PETITION FOR SPECIAL EXCEPTION

The undersigned, legal owner(s) of the property situate in Baltimore County and which is described in the description and plat attached hereto and made a part hereof, hereby petition for a Special Exception under the Zoning Law and Zoning Regulations of Baltimore County, to use the herein described property for _____ Class B Office Building in R-O Zone _____

SPODAK OFFICE BUILDING

PROJECT NAME: Spodak Office Building
PROJECT NUMBER: 85079
LOCATION: 1018 Dulany Valley Road
DISTRICT: 9C4

PLAT TO ACCOMPANY
PETITION FOR SPECIAL EXCEPTION

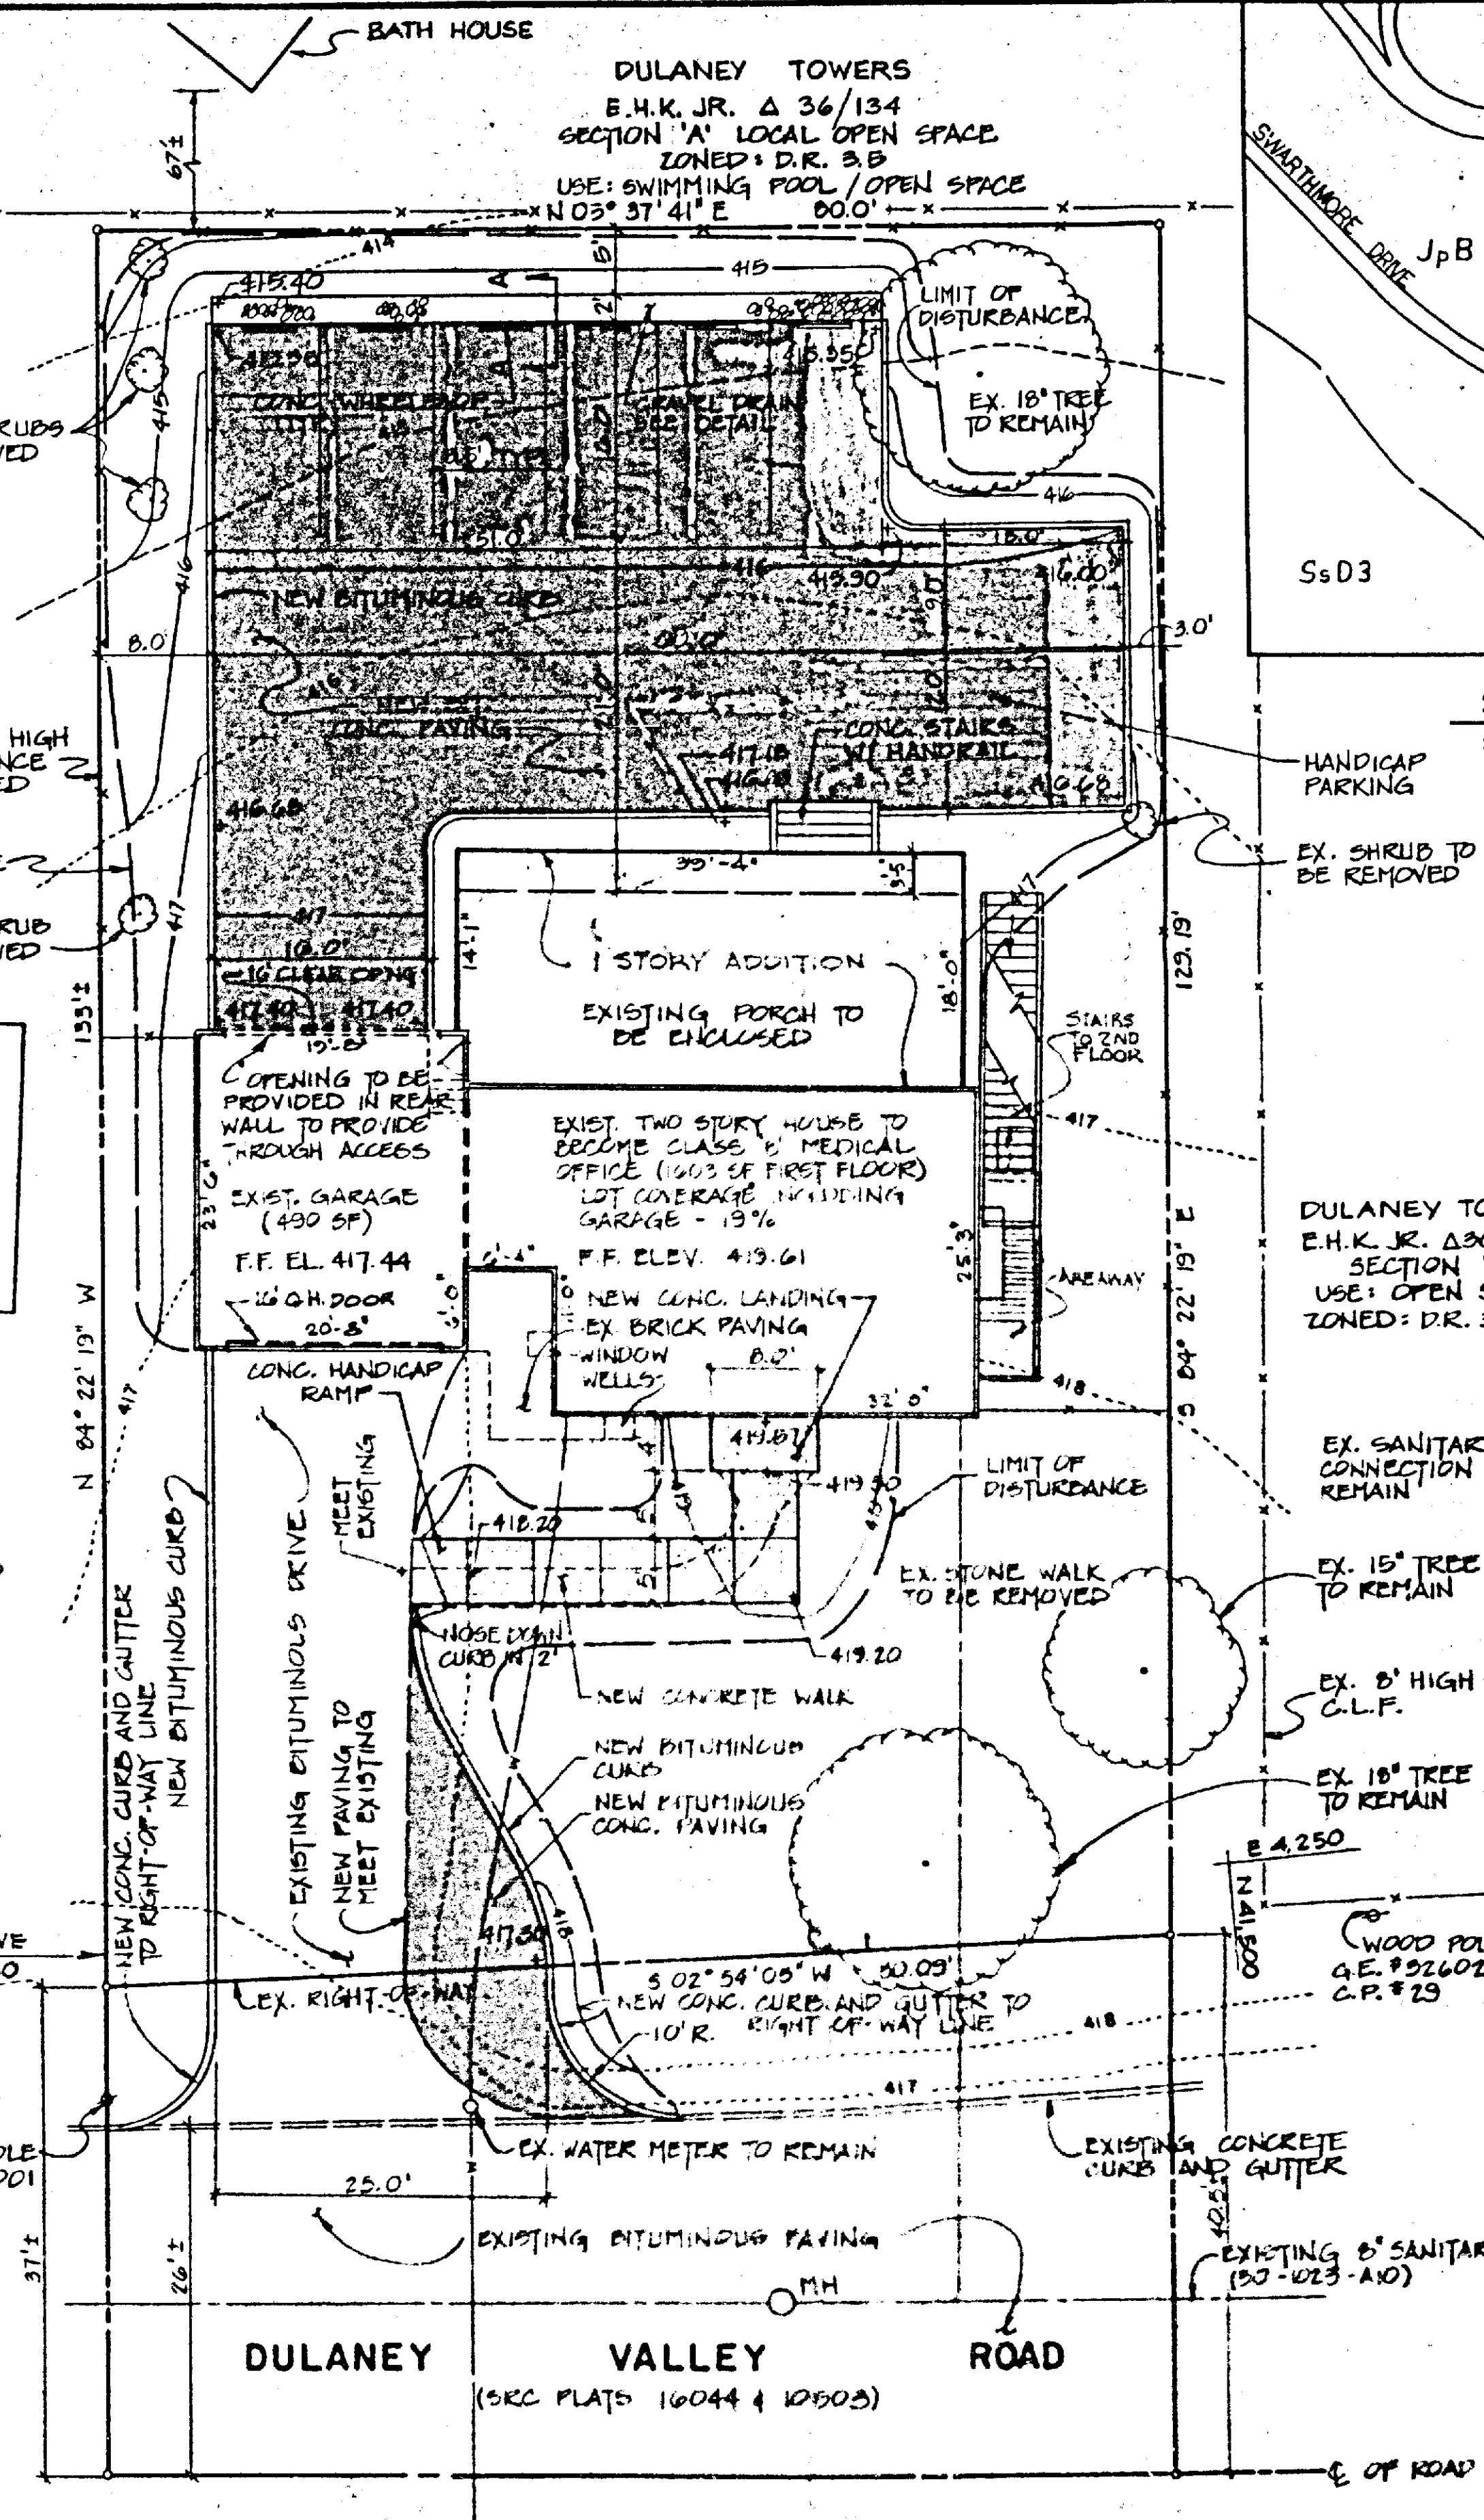
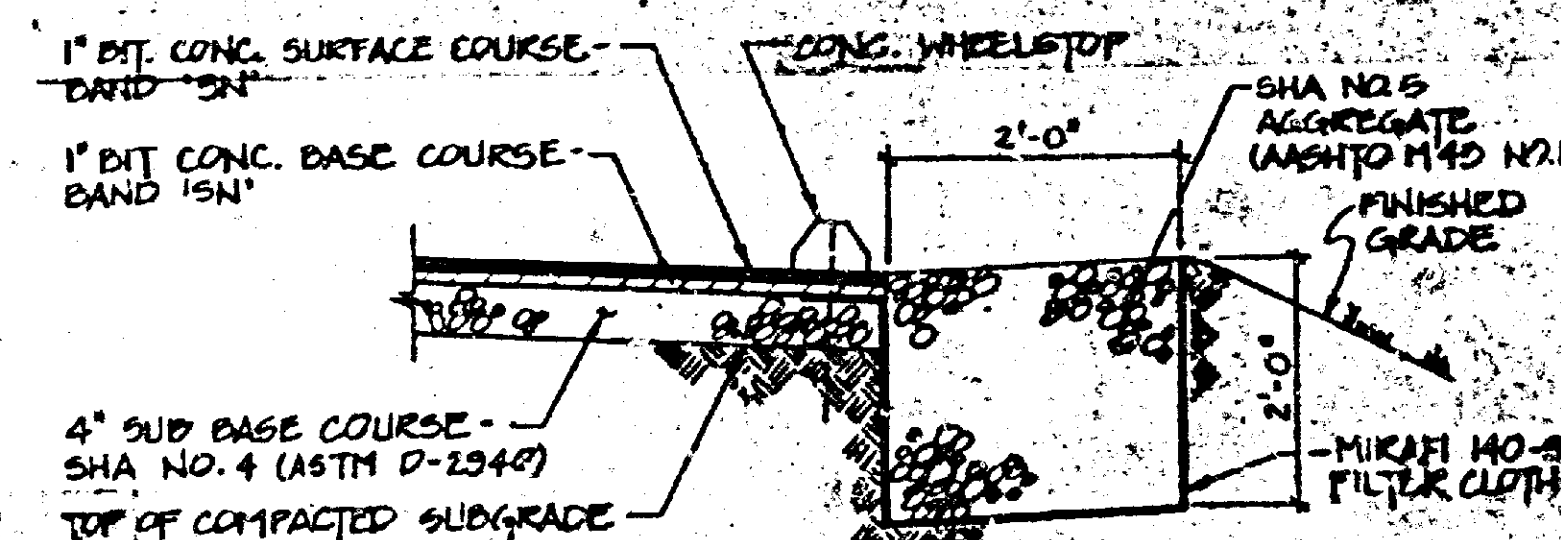
2. The following minor revisions are needed on the CRG plan prior to plan approval:
 - A. If medical offices are proposed on the 2nd floor of the building, the parking requirements are 1 parking space per 300 square feet of floor area or 3 parking spaces instead of the 2 shown. The total number required would be 8 which is the number shown.

- B. Elevation drawings or photographs must be provided for all four sides of the existing house.
 - C. A note must be added to the plan which states that the maximum signage permitted is 8 square feet, non-illuminated, and that it must be on the building wall.

The landscape calculations are incorrect and must be revised as follows: 160 LF or road at 1 tree/40 LF = 4 trees. Therefore a total of 5 trees are required. The schematic landscaping as shown is acceptable with one exception. The plan shows a 5' planting/screening area between the 6 parking spaces and the Dulaney Towers development. The Landscape Manual requires an 8' planting area between parking and a residential use. The plan must be revised accordingly. As an alternative, a modification request may be submitted to this office in accordance with Section VIII of the Landscape Manual. The Final Landscape Plan prepared by a registered landscape architect must be approved by this office prior to issuance of any permits.
